**TRAFFIC AND PARKING IMPACT ASSESSMENT OF
MIXED-USE DEVELOPMENT
AT 28 LOCKWOOD AVENUE, BELROSE**

Document reference: **200622.01FA**

This letter is in response to the Northern Beaches Council's comments within a letter dated 11 August 2020 for DA No: DA2020/033. The comments made by Council relevant to traffic and parking are shown below (italicised) with *McLaren Traffic Engineering's* (MTE) response thereafter.

FIGURE 8: GLENROSE PLACE ROUNDABOUT CONCEPT

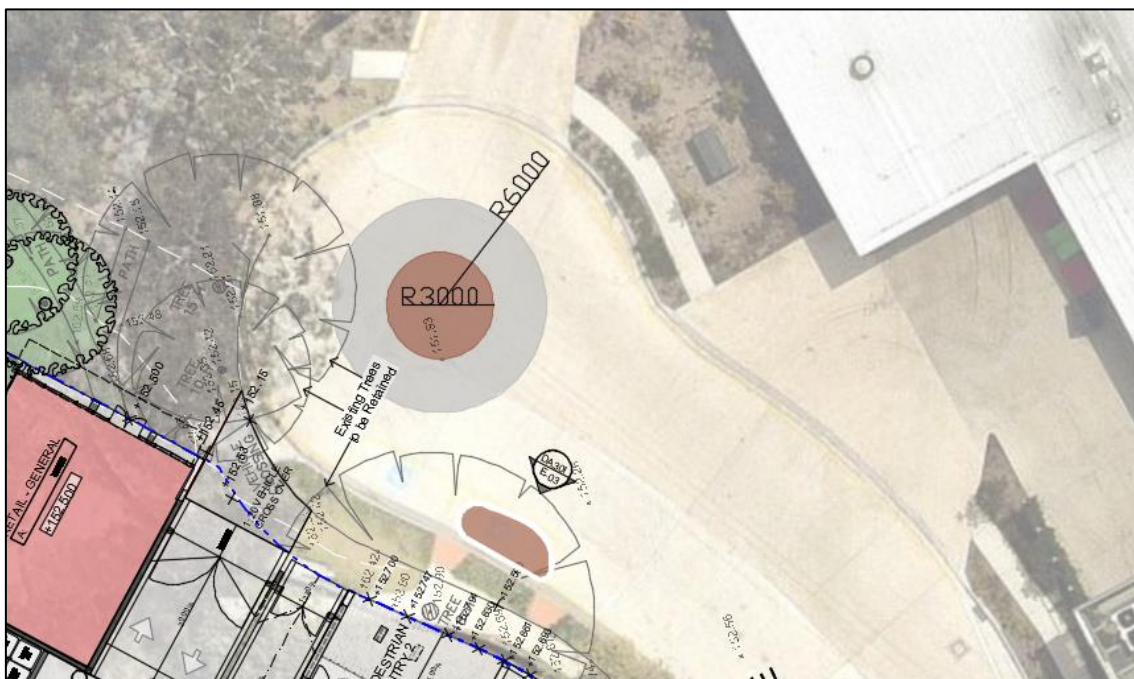
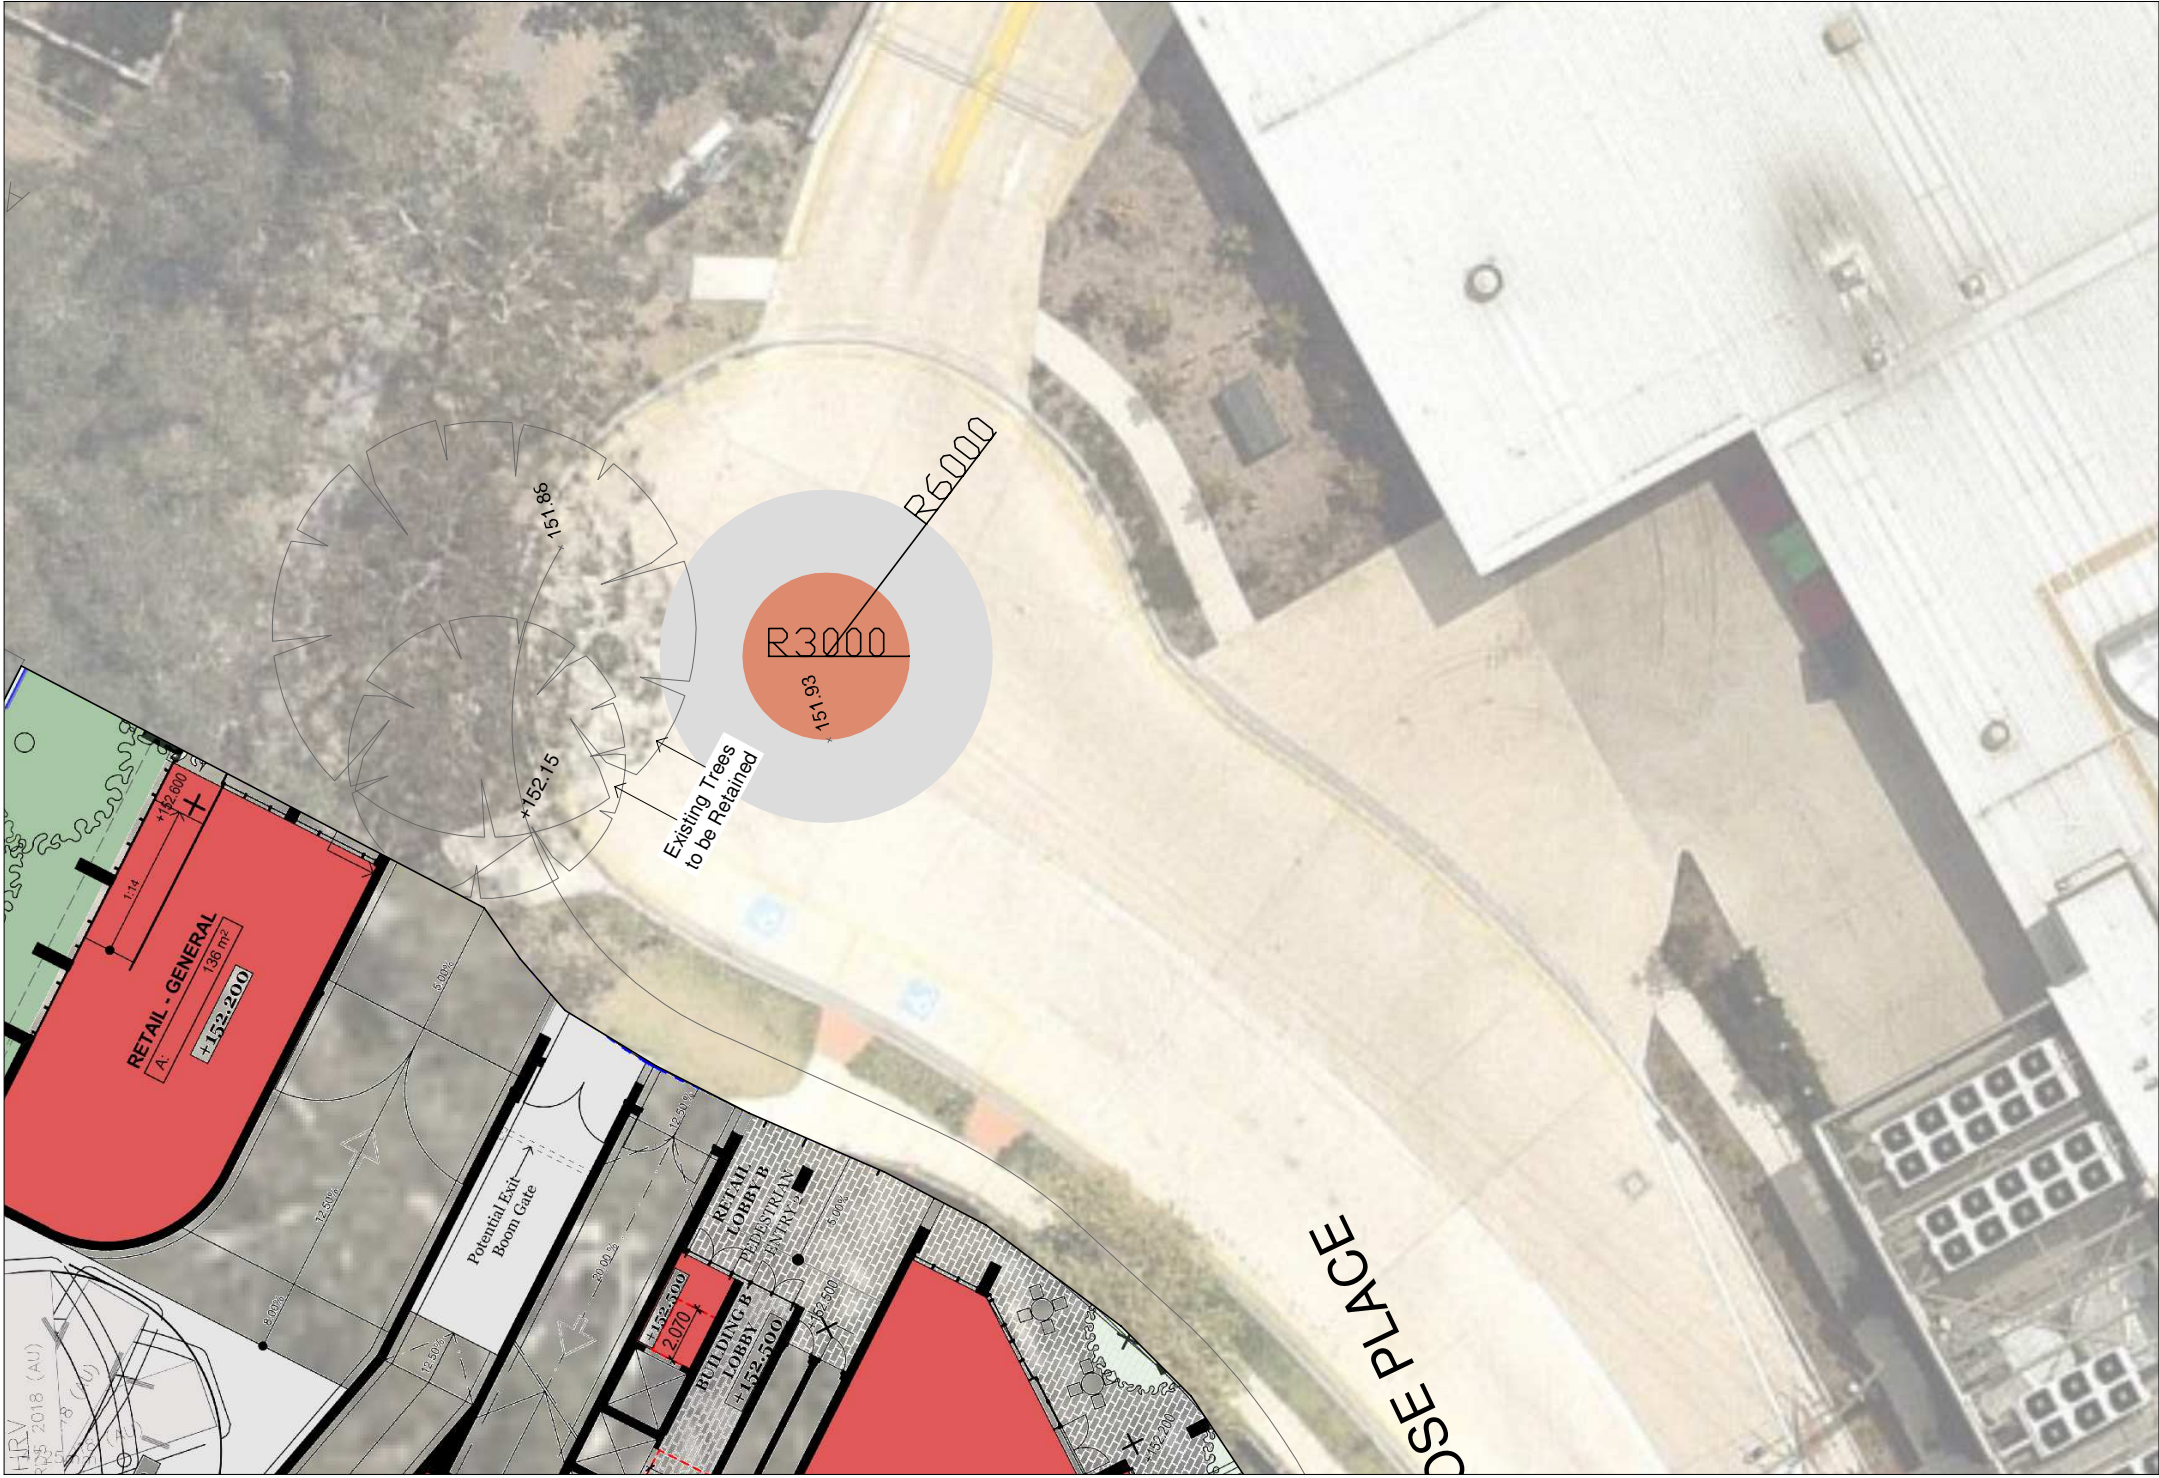
Vehicular access to the car park is proposed via separated one-way driveways from Glenrose Place. This would be considered acceptable subject to the provision of detail design of the roundabout proposed at the cul-de-sac as well as the provision of separated vehicular access for service vehicles as explained later in the assessment comments.

MTE Response: A concept design for the proposed roundabout is provided in **Annexure E**. This concept provides adequate turning facilities for the design vehicle, which is a 12.5m length Heavy Rigid Vehicle. The detailed design of the roundabout is for others to address.

FIGURE 10: HRV SWEEP PATHS OVERLAID ONTO A PEDESTRIAN REFUGE

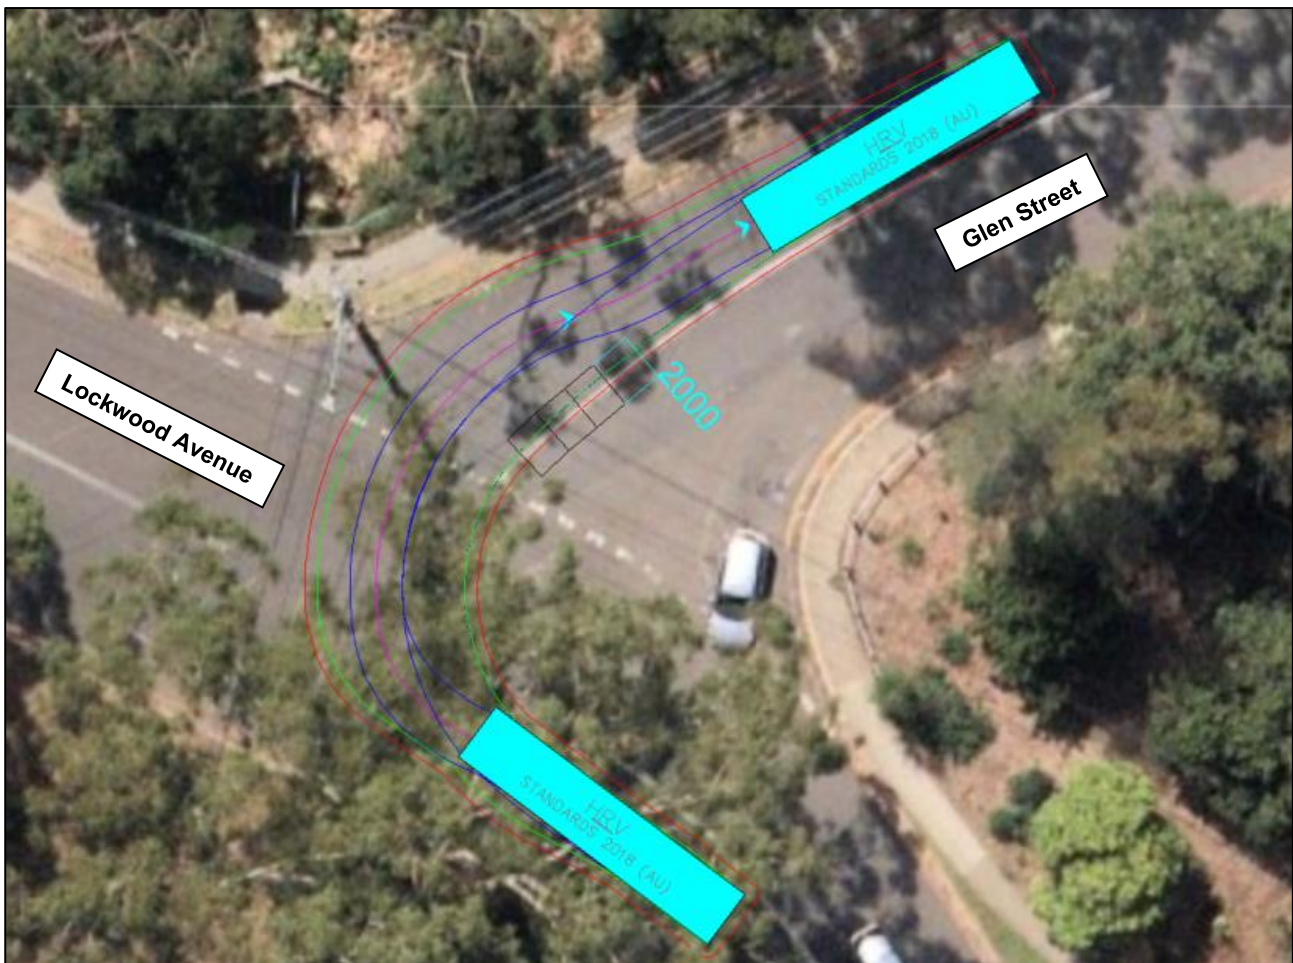
Pedestrian refuge island on Glen Street at its intersection with Lockwood Avenue

Glenrose Village has a supermarket which serviced by HRVs. Swept path analysis has been completed showing a 12.5m length HRVs turning right onto Glen Street from Lockwood Avenue. MTE has overlaid a 2m width pedestrian refuge island on an aerial image. This is the minimum pedestrian refuge width in accordance with *Figure 7 of AS1742.10*. The swept path tests of the HRV on this aerial are shown in **Figure 10**.

As shown, the HRV paths conflict with the pedestrian refuge which Council has requested. If a pedestrian refuge were to be installed in this location, it would prohibit delivery vehicles from arriving to the proposed development and Glenrose Village from this direction.

In summary, the requested pedestrian refuge would limit service vehicle routes to the site and would provide no meaningful benefit to pedestrians within the area. Therefore, the requested pedestrian refuge is not appropriate.
